**DOCUMENT 00 90 00**  
**ADDENDUM**

**ADDENDUM No.:** 2

**DATE:** April 1, 2025

**RE:** WESTERN TECHNICAL COLLEGE  
STUDENT SUCCESS CENTER RENOVATION  
400 N. 7TH STREET  
LA CROSSE, WISCONSIN 54601

ED05

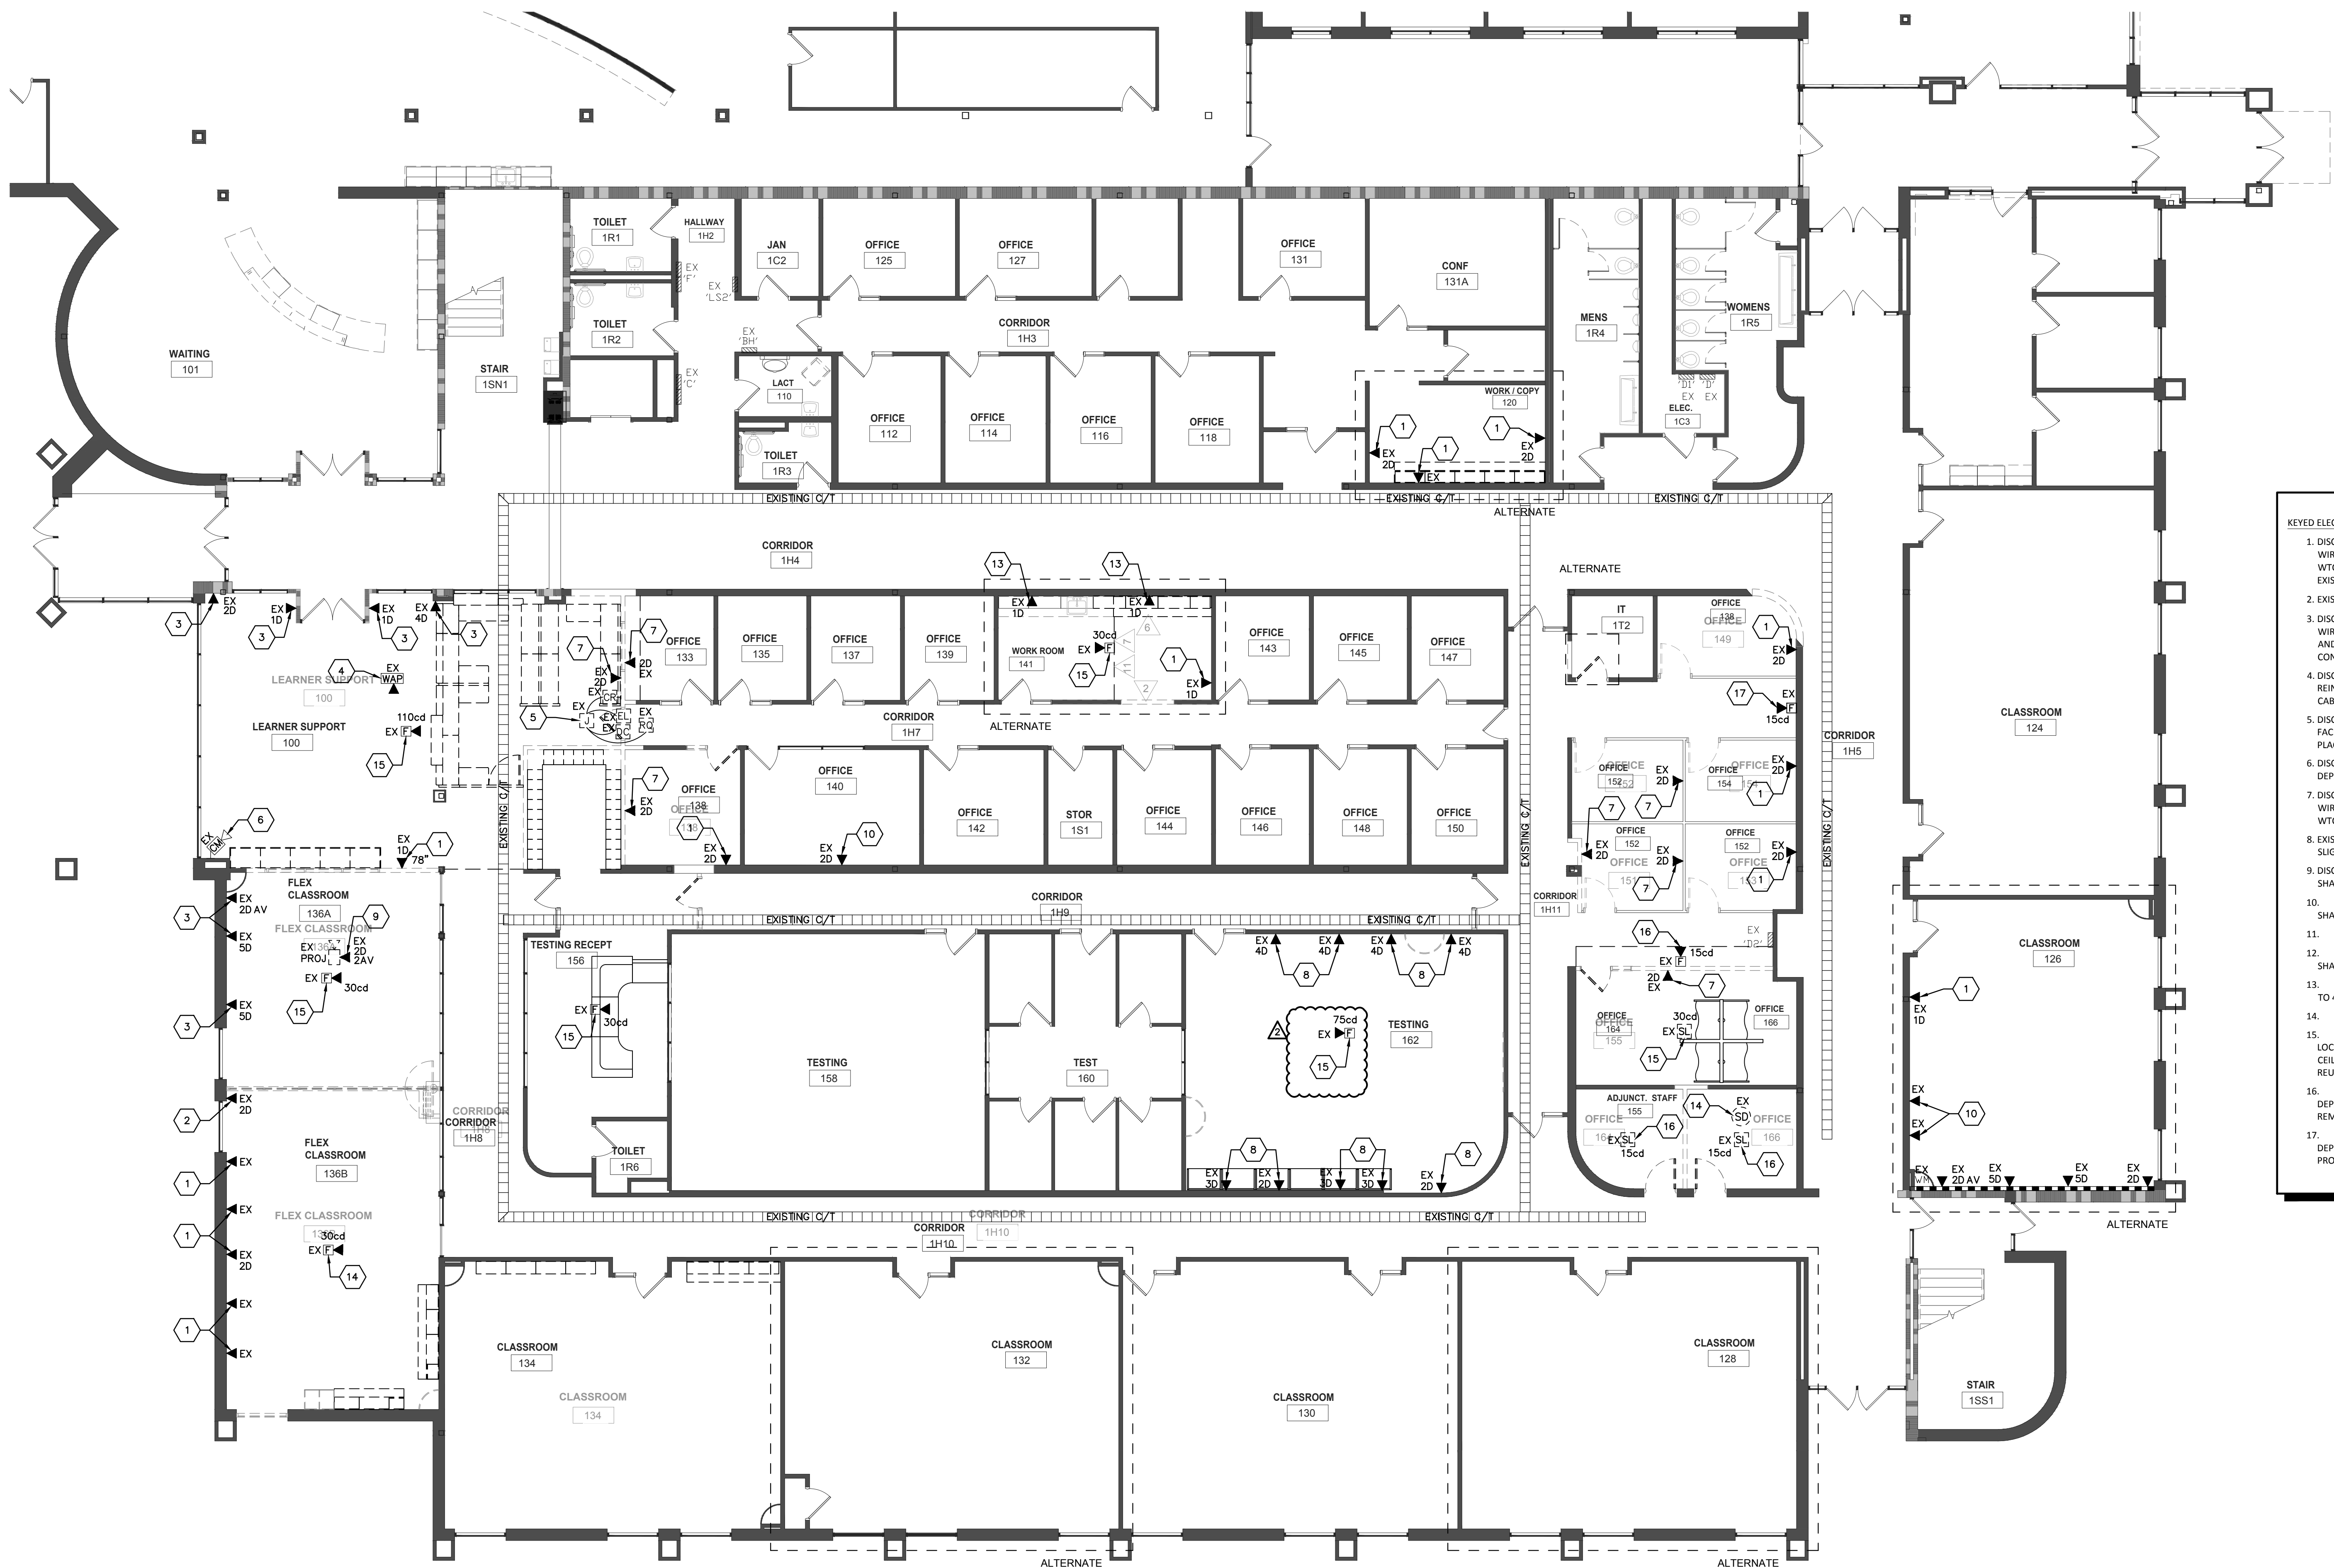
- c. Disconnect Two (2) existing Circulating Water Pumps and associated VFD Drives. Refer to clouded change labeled addendum 2.
13. Sheet ED05 FIRST FLOOR LOW VOLTAGE DEMOLITION PLAN 30"x42"

- a. See the revised sheet included in this addendum. Disregard the previous version.
  - b. Refer to Testing Room #162;
    - i. Refer to Fire Alarm work in this room, refer to clouded change labeled addendum 2.

# 1 FIRST FLOOR LIGHTING PLAN

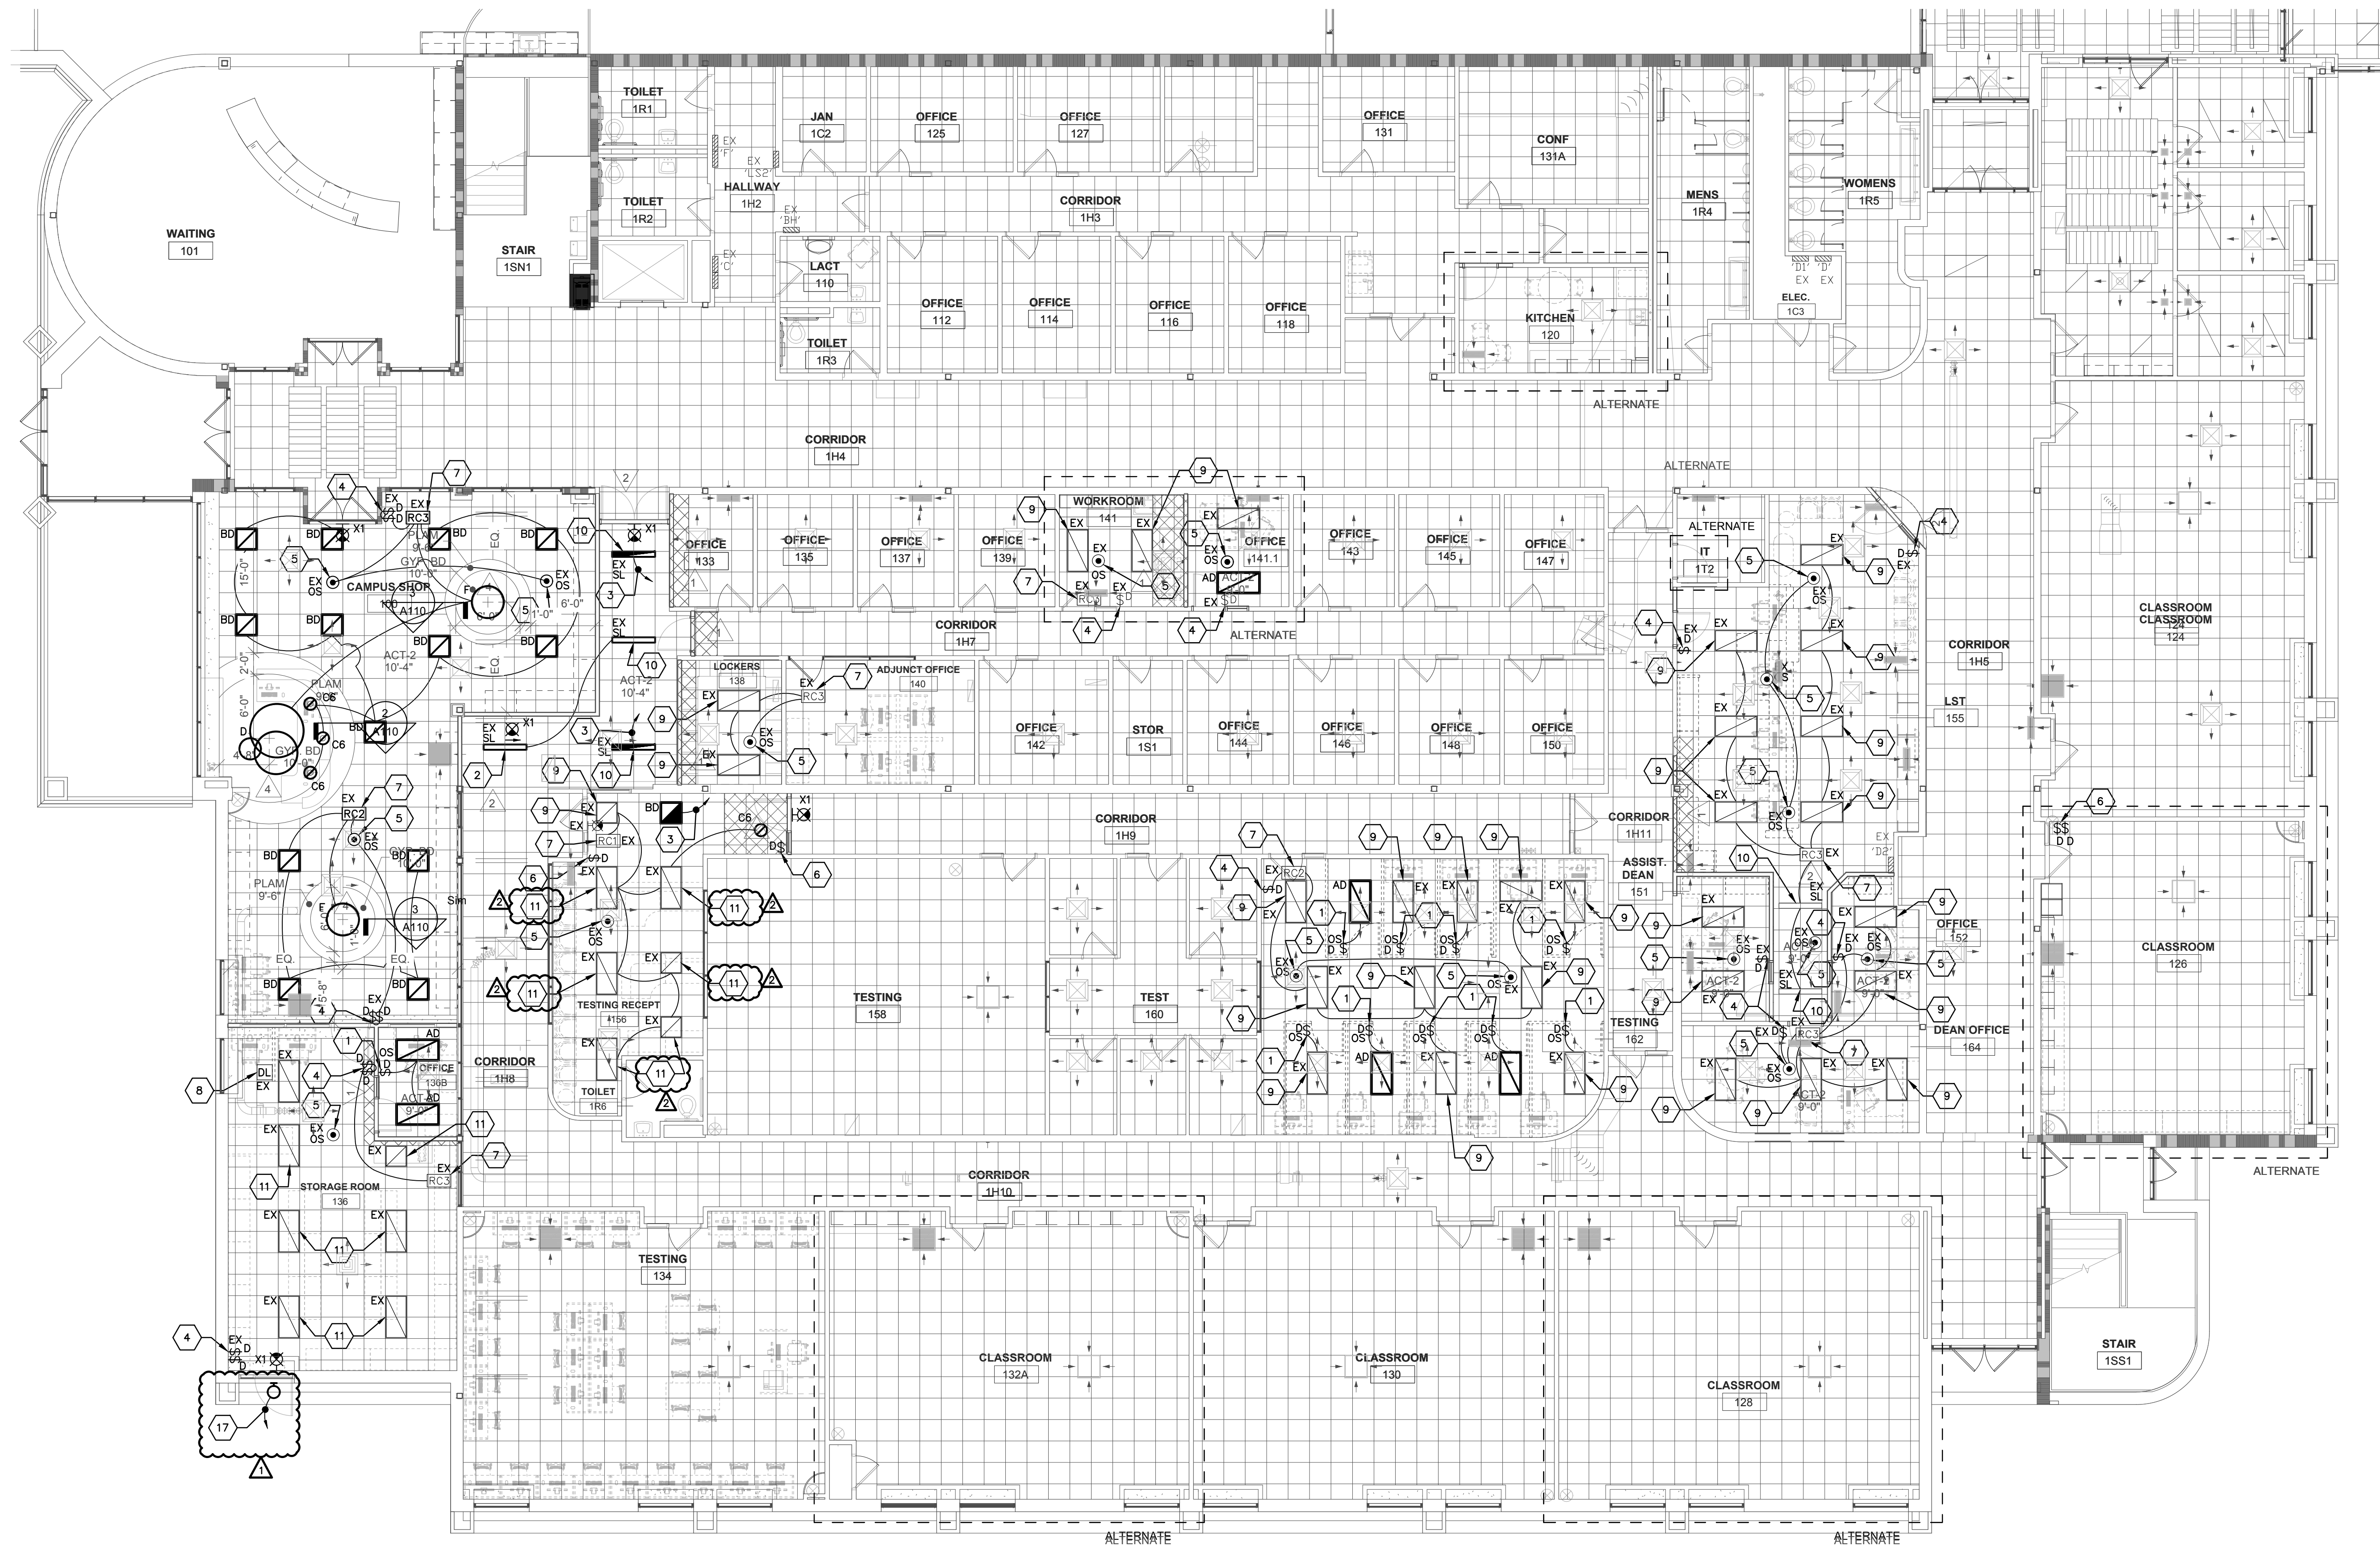
14. Sheet E101 FIRST FLOOR LIGHTING PLAN 30"x42"
  - a. See the revised sheet included in this addendum. Disregard the previous version.
  - b. Several changes were made to this sheet, refer to clouded changes labeled addendum 2.

E202

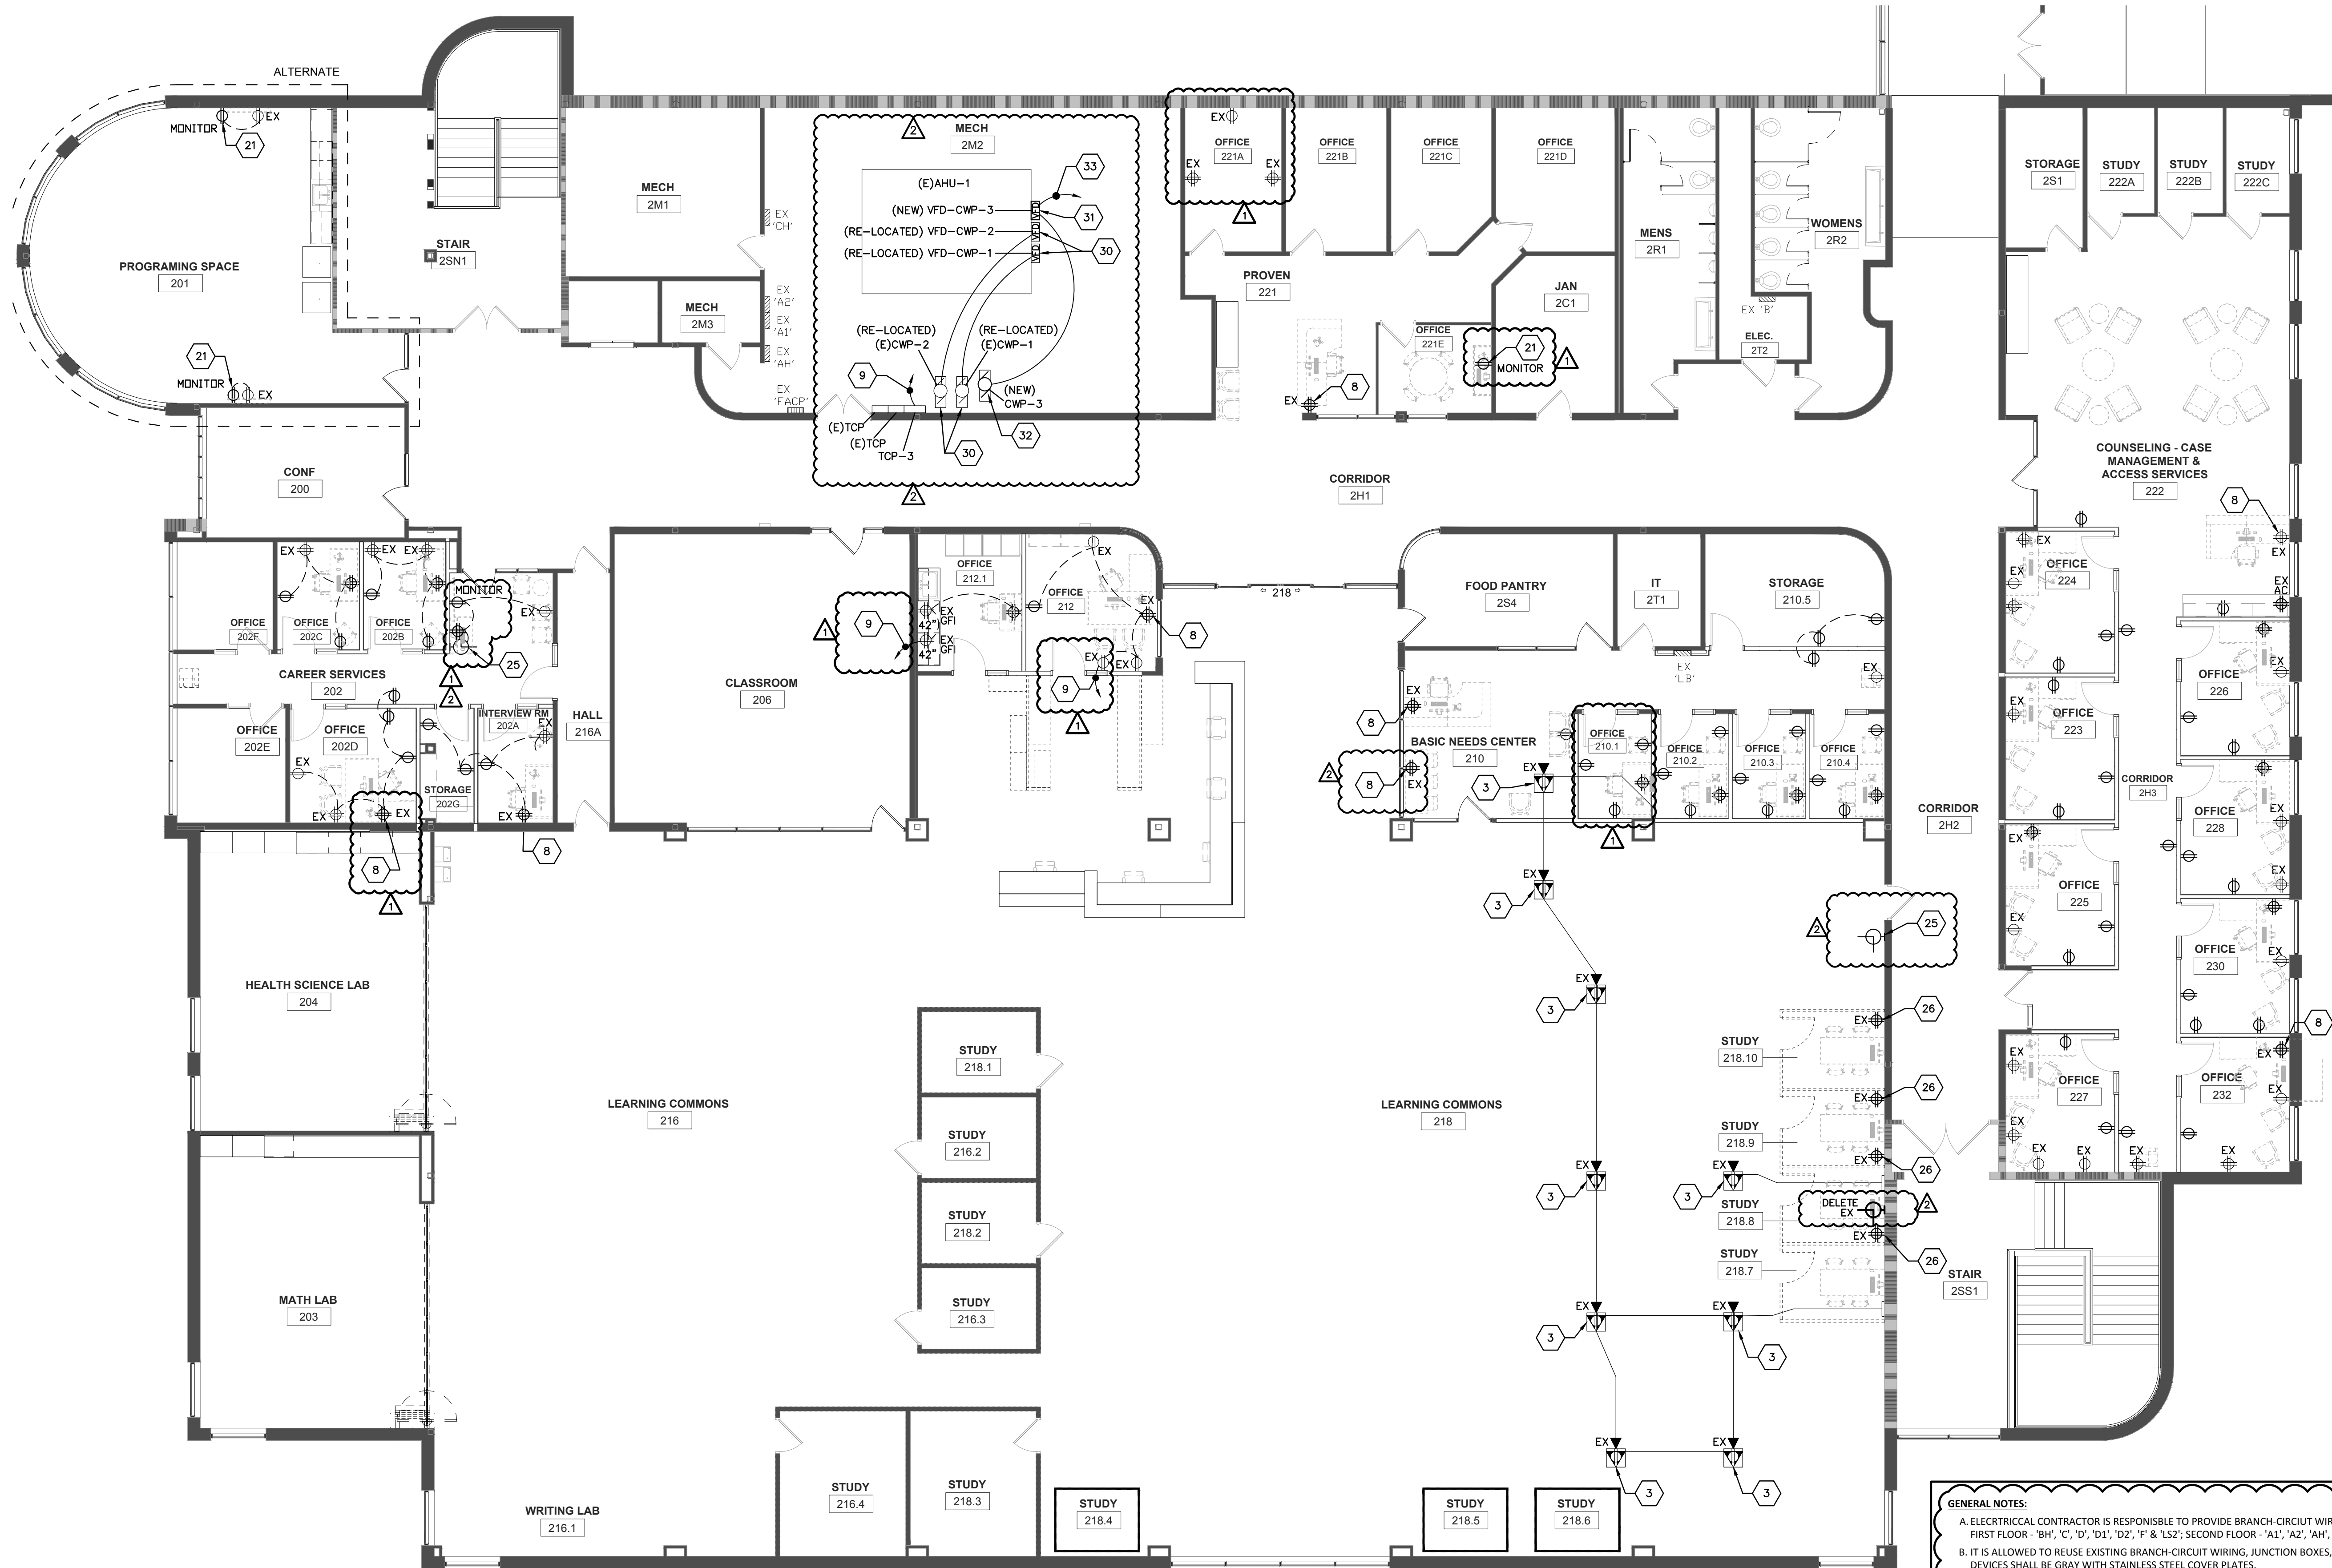
17. Sheet E202 SECOND FLOOR POWER PLAN 30"x42"
  - a. See the revised sheet included in this addendum. Disregard the previous version.
  - b. Several changes were made to this sheet, refer to clouded changes labeled addendum 2.
